# CHANGE ORDER

Project Name: **Haverhill Consentino Middle School** CO No. **08**

Subject: **Connector C Stairs**

**TITLE:** PR-32 Connector C Stairs

MILLWORK PLAN - STAIR 5 BENCH

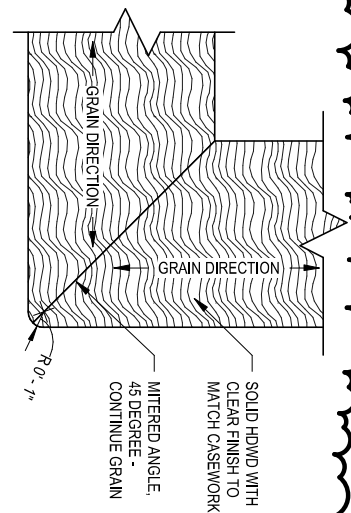
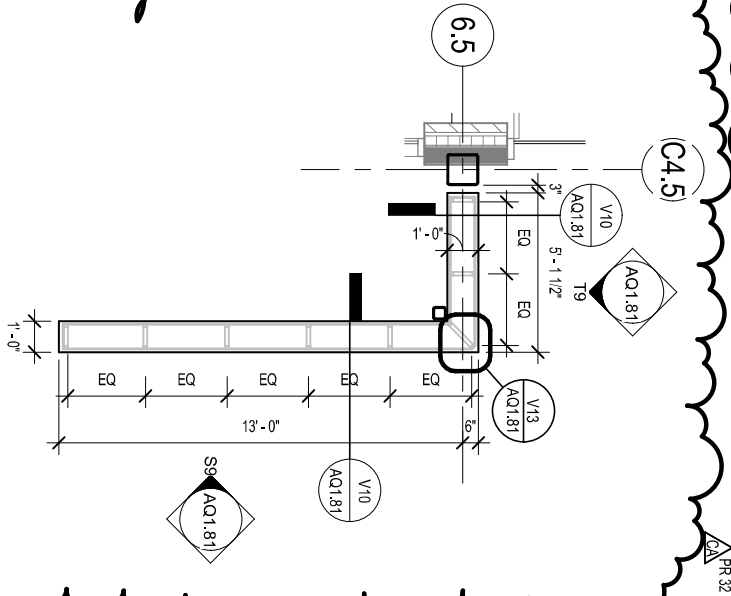
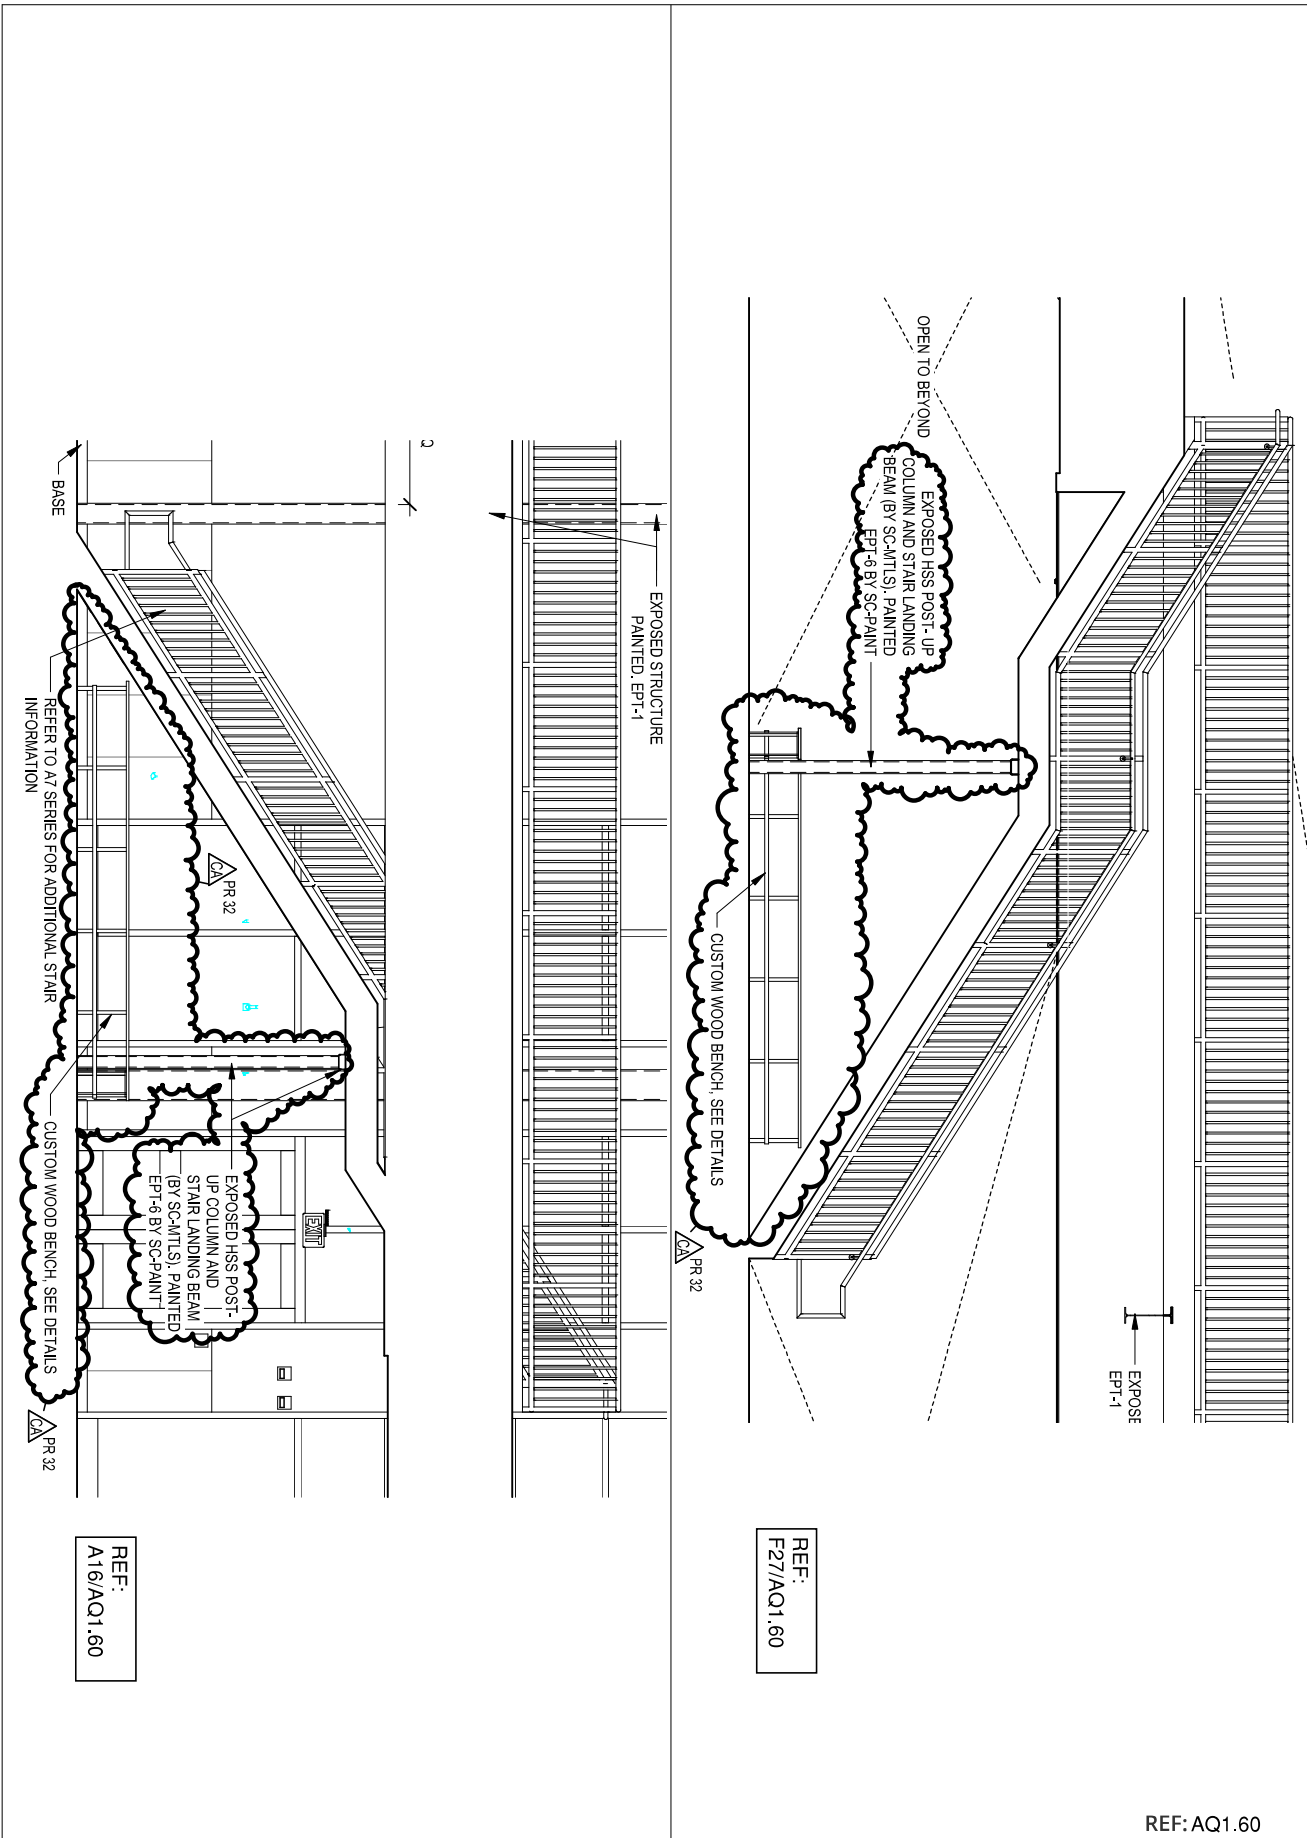
Assumed labor to install new bench vs old bench (14'-0") would be the same, plus additional 18'-0" of bench

Field labor -- \$28 per LF of bench in Credit vs \$125 per LF for new?

Add custom metal framed, wood top bench under stairs. Refer to attached sketch **JD-67, JD-68, and JD-69.**

CORRIDOR 1069 AND 2022 REVISIONS:  
ADD UNDER STAIR BENCH / HSS POST-UP

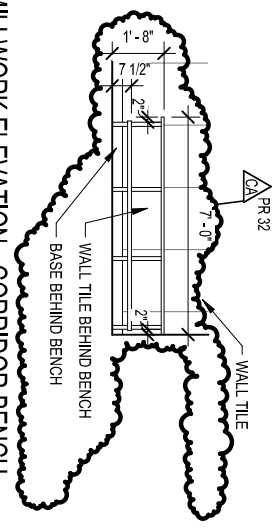
Delete Rail Type 5 below stairs and provide credit. Refer to sketches **JD-66, JD-68, and JD-69.**

Add steel HSS post-up to plan and section to coordinate with Misc Metal Stair Submittals. Refer to attached sketches **JD-66 and JD-68.**

INTERIOR ELEVATION - CORRIDOR 1063 / 2021 - SOUTH

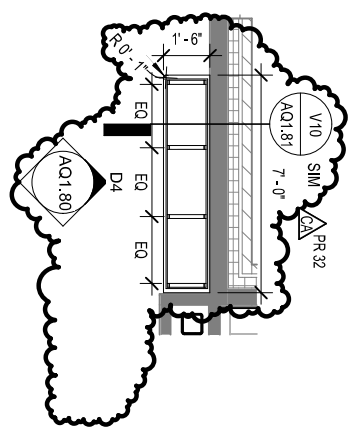
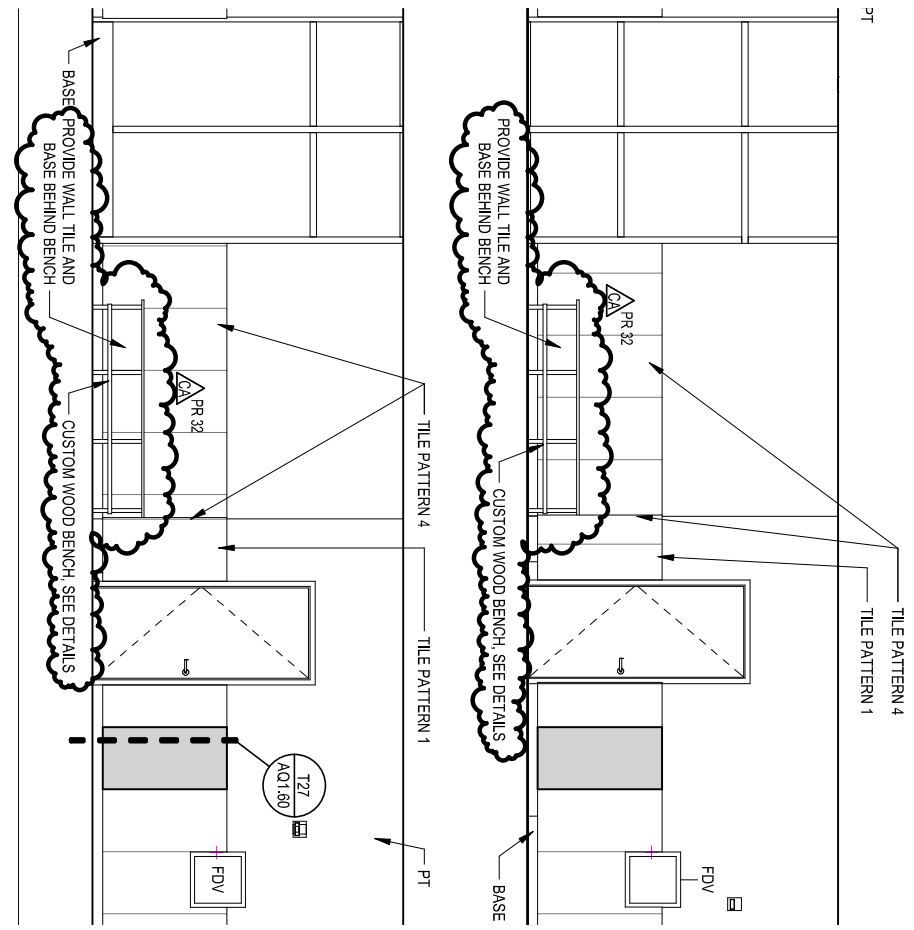
Revise the existing corridor benches at Connector C as shown in attached sketch **JD-67 and JD-69.**

Wall tile shall continue behind bench.
